RE: **Lot 15 Block 2 Volcano Cliffs SAD 228**
6508 Camino Del Oeste NW
Grading and Drainage Plan
Engineers Stamp Date 10/9/17 (D10D003G15)

Based upon the information provided in your submittal received 10/11/17, this plan is approved for Grading Permit.

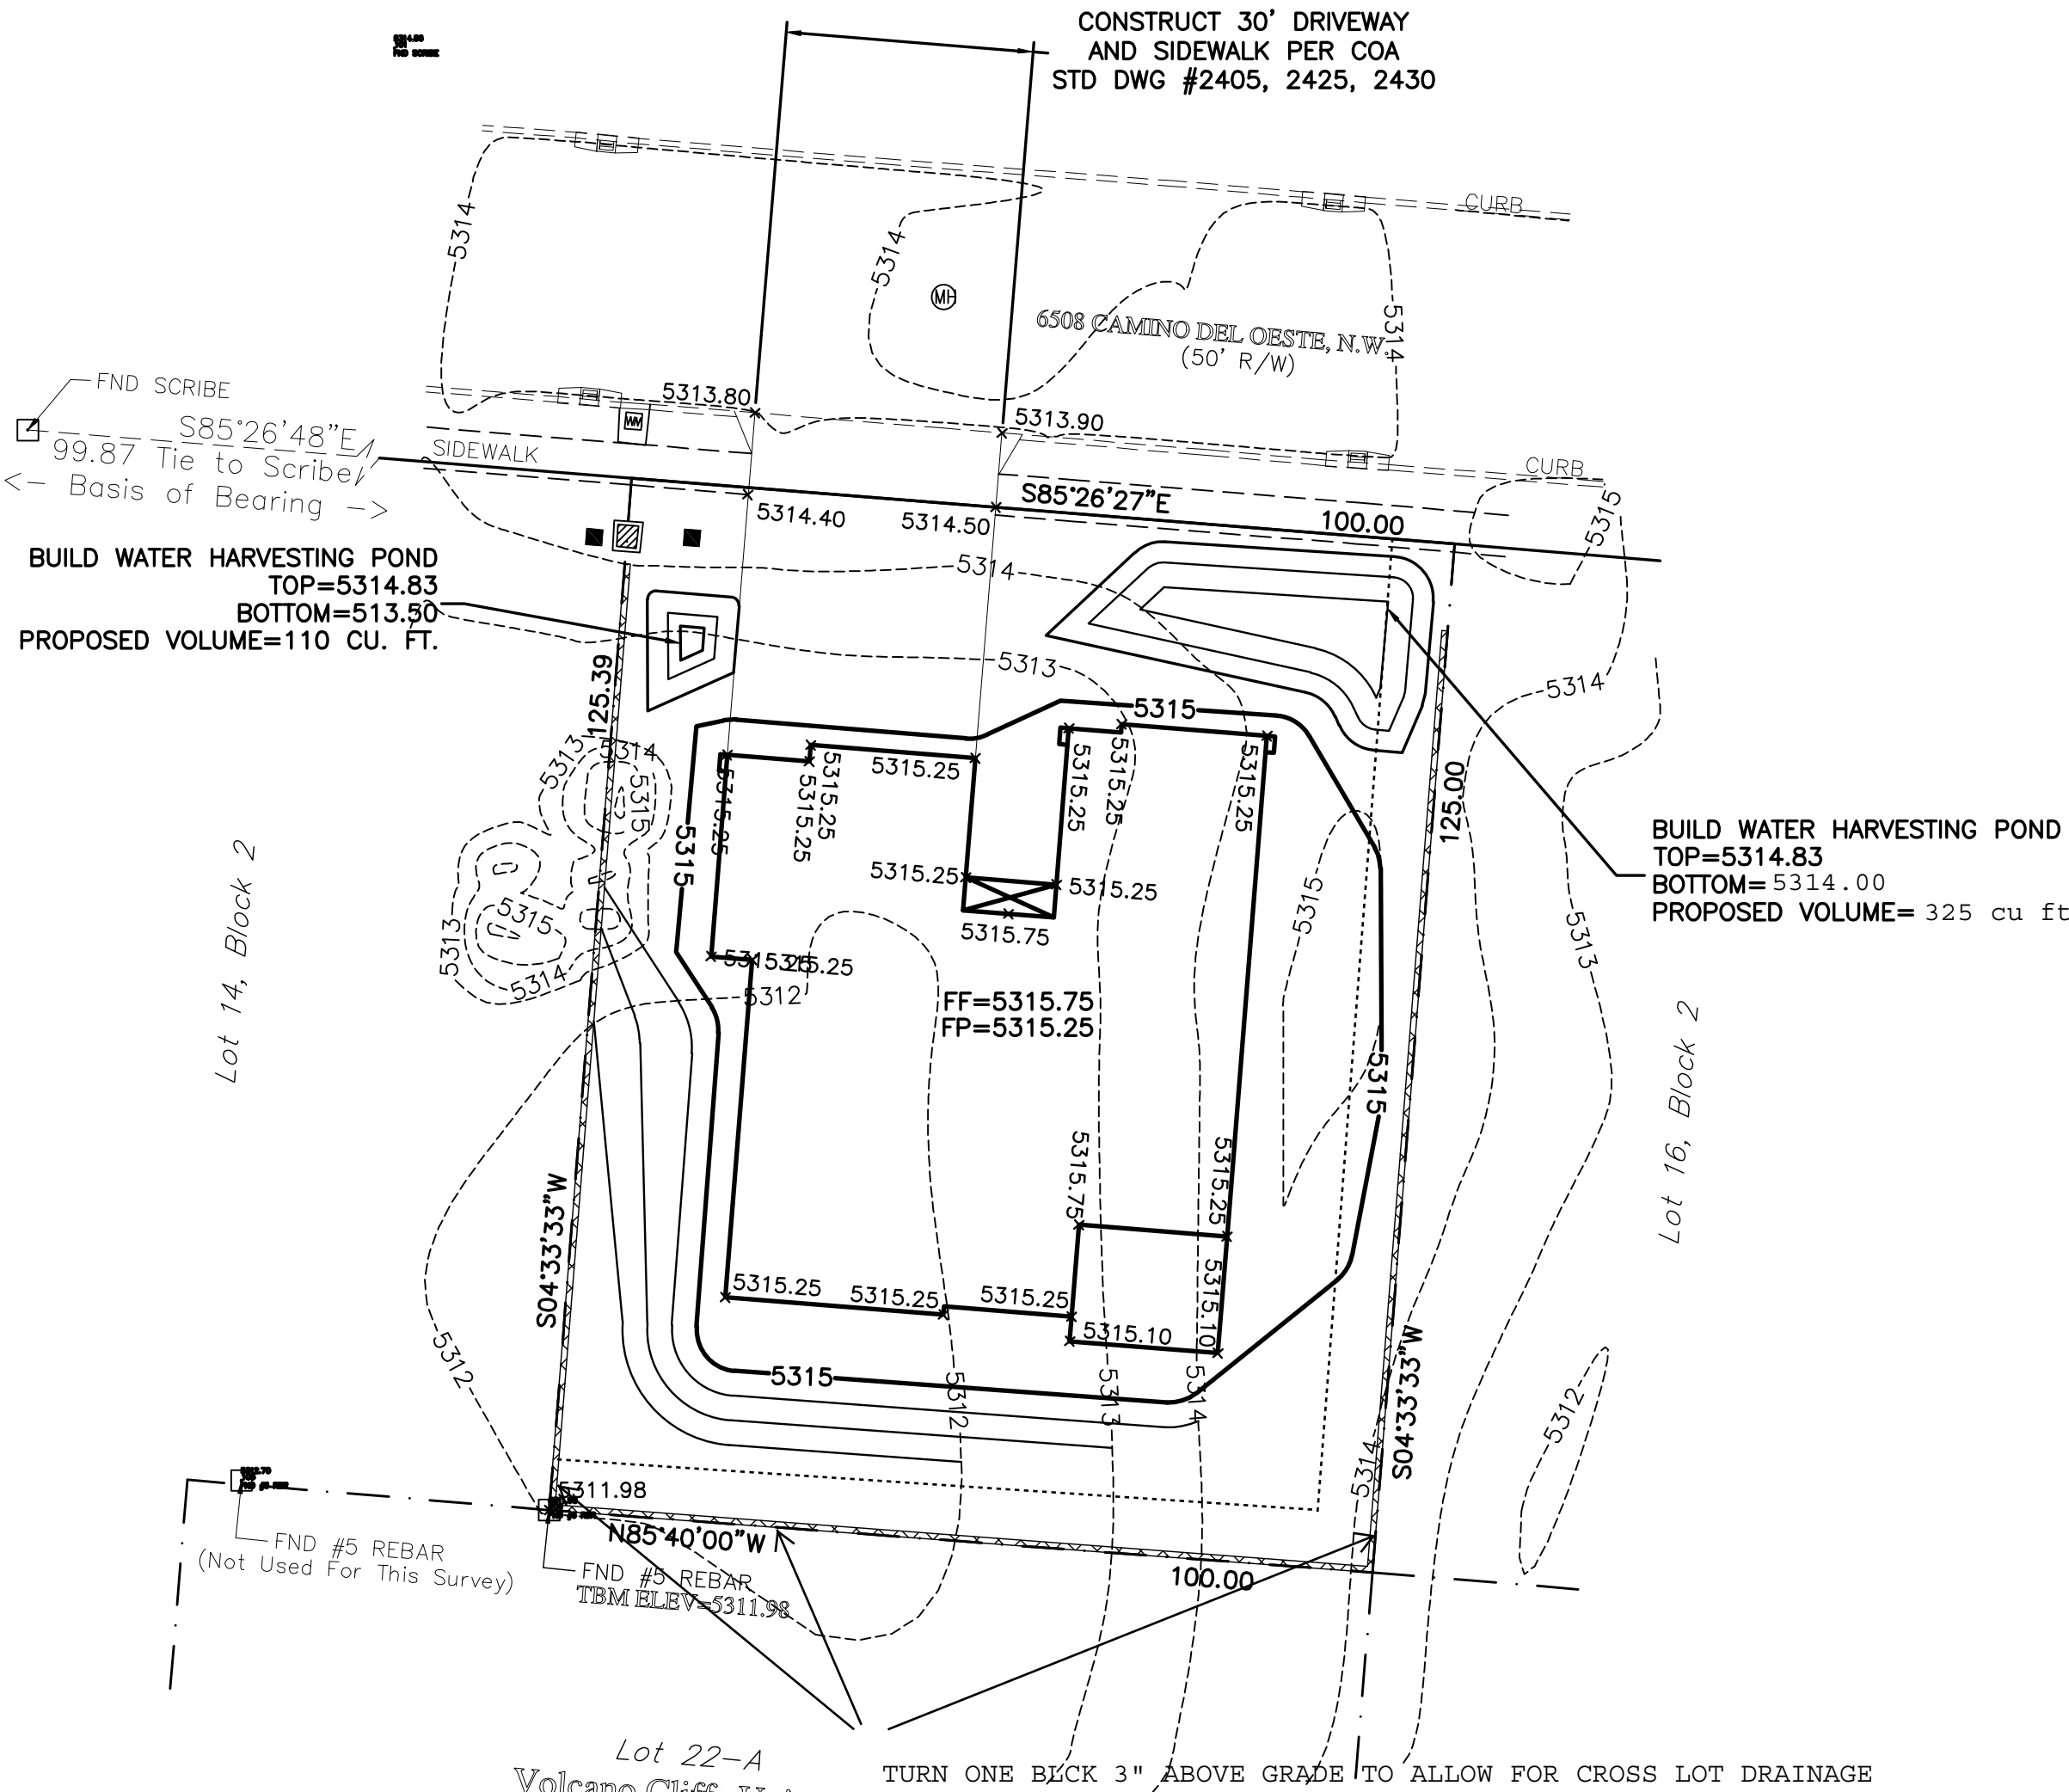
Prior to Building permit approval a Pad Certification will be required, provided by the Engineer or a registered Land Surveyor.

Reiterate to the Owner/Contractor that a separate permit for a garden/retaining wall must be obtained, with the approved G&D plan dated 10/9/17.

Prior to Certificate of Occupancy release, Engineer Certification per the DPM checklist of this plan will be required.
